E8364A-01B**S E R V I C E****N O T E**Supersedes:
E8364A-01A**E8364A PNA Series RF Network Analyzers**

Many of the Front Panel Interface (FPI) boards which were installed per Service Note E8364A-01A need to be modified or replaced because the RPG shaft can disconnect, and the front panel keyboard and RPG can respond intermittently upon boot up.

Figure 1

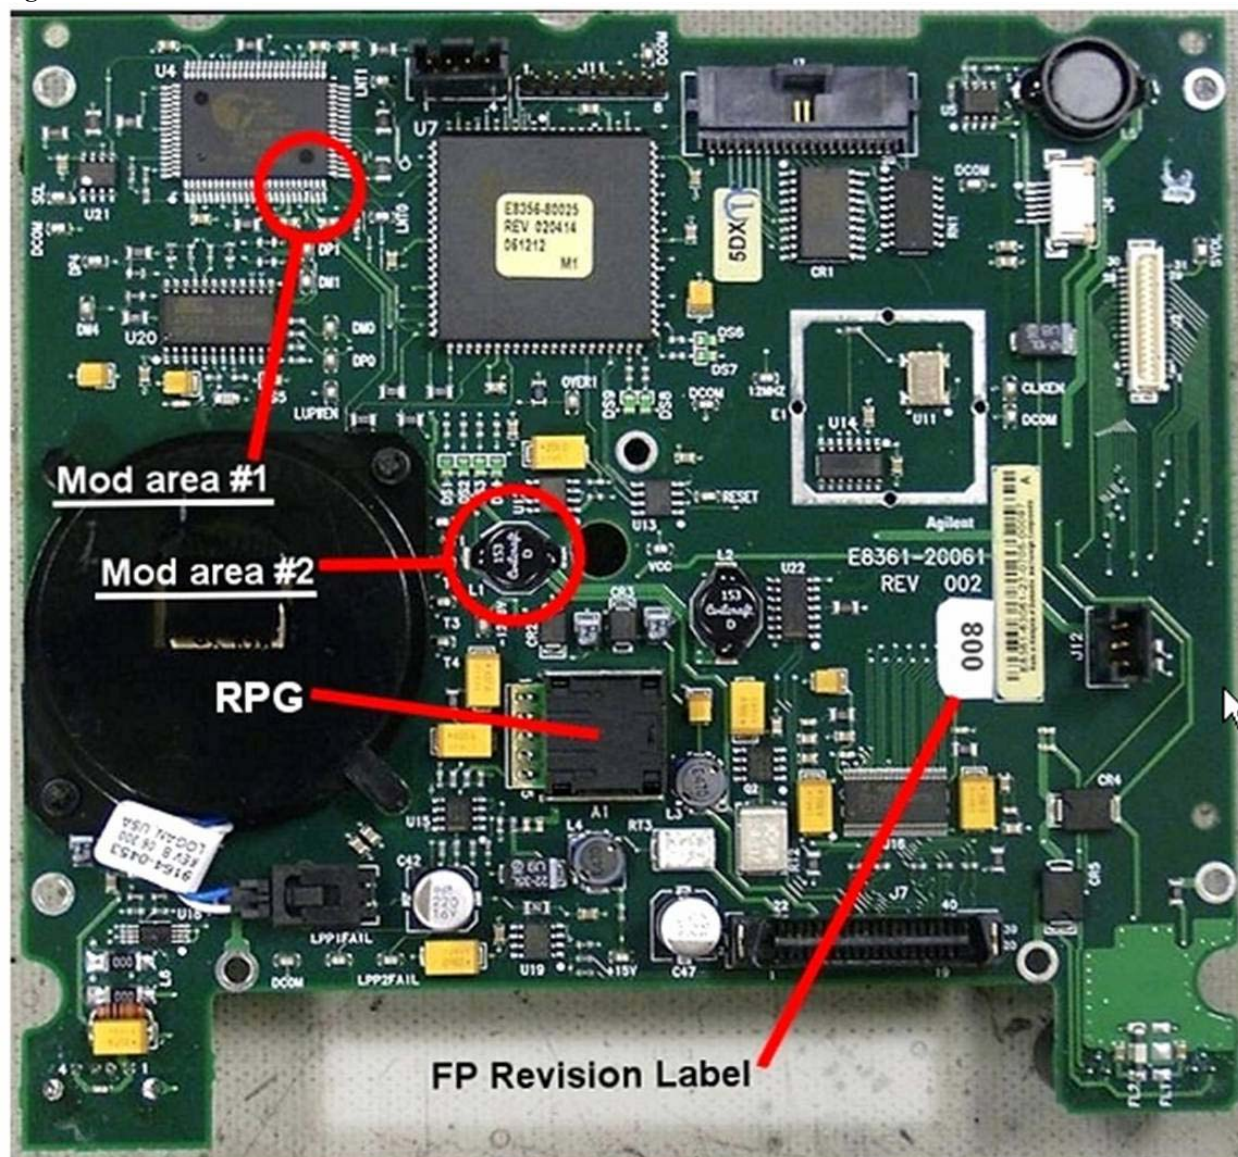
Refer to Figure 1 for the two modification areas to be addressed. Note that while this picture happens to show the FPI board completely removed from the front frame assembly, this is not necessary to perform the required modifications.

- Modification #1 consists of shorting two pins of U4 together with a small amount of solder.
- Modification #2 consist of removing L1.

Figure 2

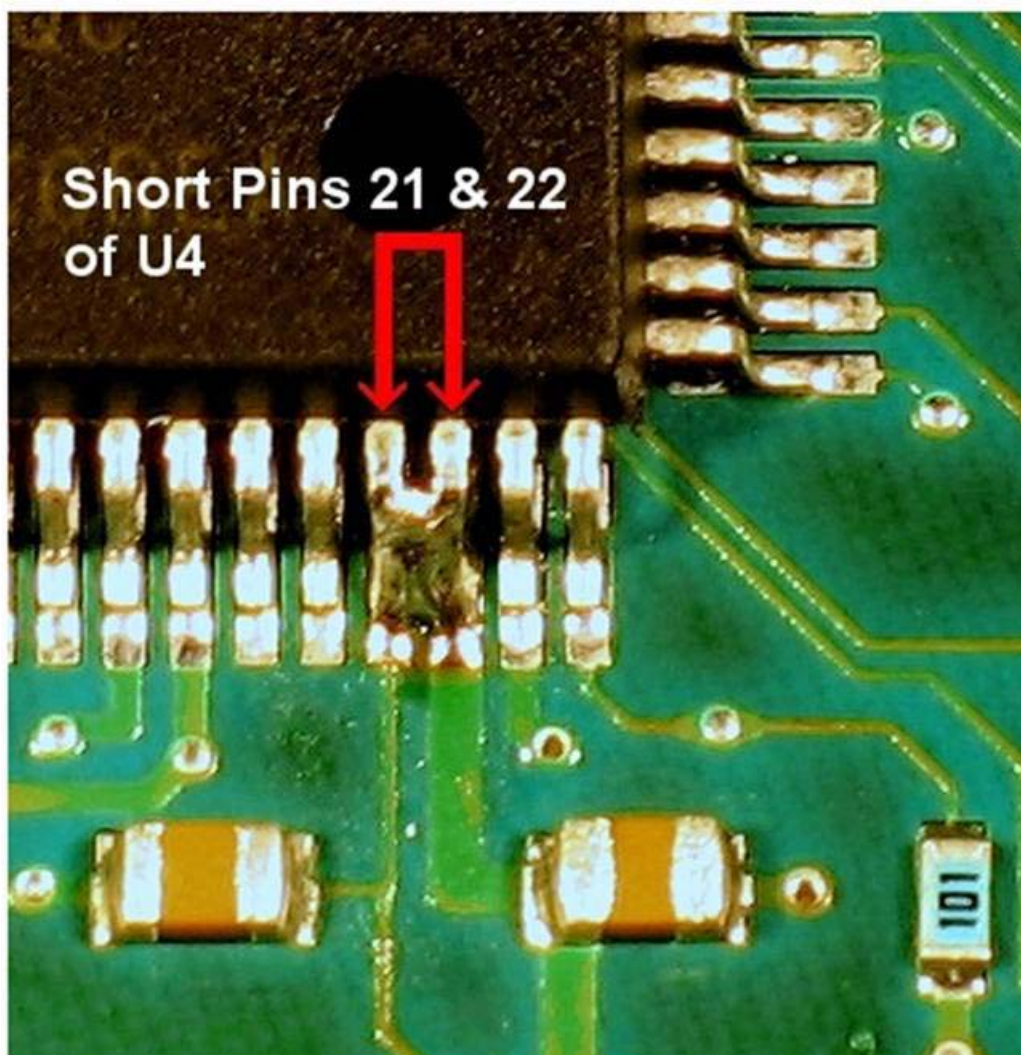
Carefully solder pins 21 and 22 together on U4. Refer to Figure 2 for the exact location. Use care so that no other pins are shorted. Use of a very fine tip soldering iron is recommended and a large work-task magnifying glass is very helpful.
